### ANN ARBOR HISTORIC DISTRICT COMMISSION

### **Staff Report**

ADDRESS: 403 Second Street, Application Number HDC25-0131

**APPLICATION:** The applicant seeks HDC approval to construct a basement egress window and well on the north elevation and to convert a door opening on the west elevation into an egress window. Also included in the application are: an additional basement egress window on the south elevation, removal of non-original siding and trim, un-enclosing the porches, replacing the front door, removing the chain link fence, installing a new on-grade patio, and replacing the garage doors.

SIDE / NORTH ELEVATION

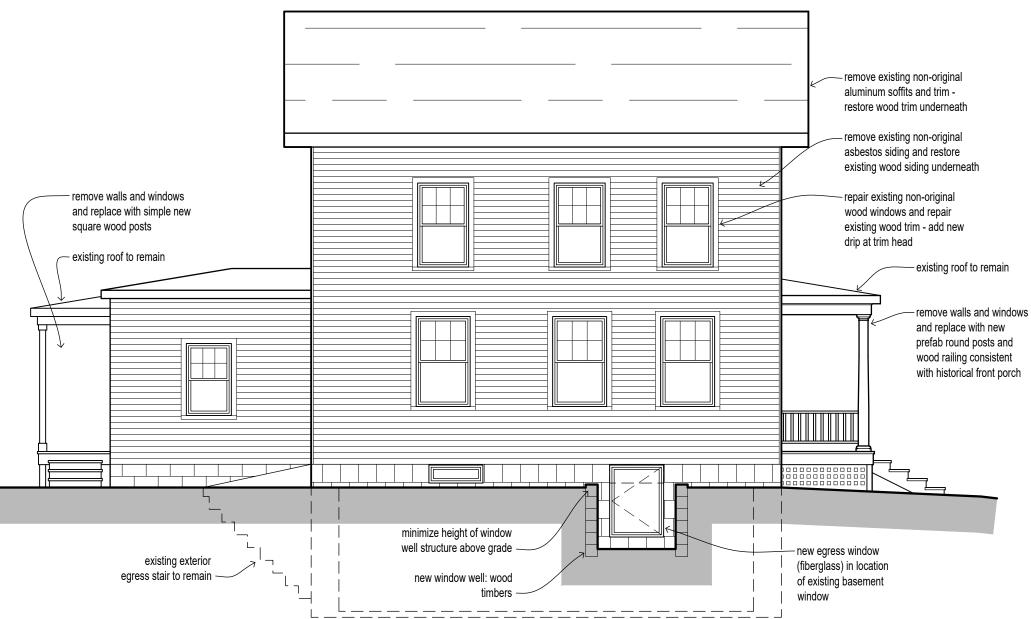
The third egress window will be on the north elevation (facing William Street), near the front of the house. There is an existing window in this location, but the opening is proposed to be enlarged for egress purposes. New landscaping (3ft bushes scattered across the north side of the house) is proposed to screen the new window well. The grade of the site will also help shield the window well from the right of way.

The new egress window on the south elevation and the converted egress window on the east elevation are in appropriate locations. Egress windows on highly visible elevations are not appropriate, but the applicant has explained that the chosen location for the third egress well on the north elevation is the only possible location. There are limited possibilities given that the house is on a corner lot. Converting an existing basement window keeps the fenestration pattern, and the applicant has proposed new landscaping as screening.

SIDE / SOUTH ELEVATION

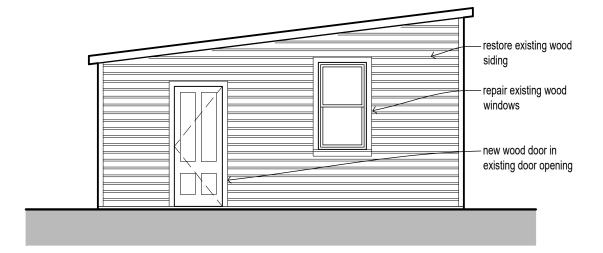
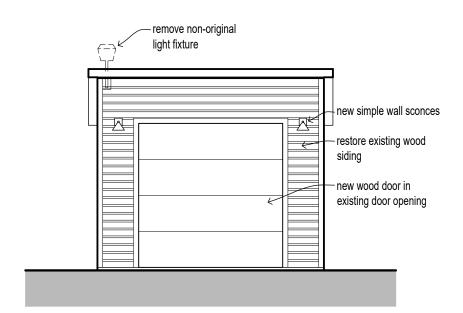
The applicant proposes adding three new basement egress windows. The first will be on the south elevation of the one-story rear portion of the house and will not be visible from the street.
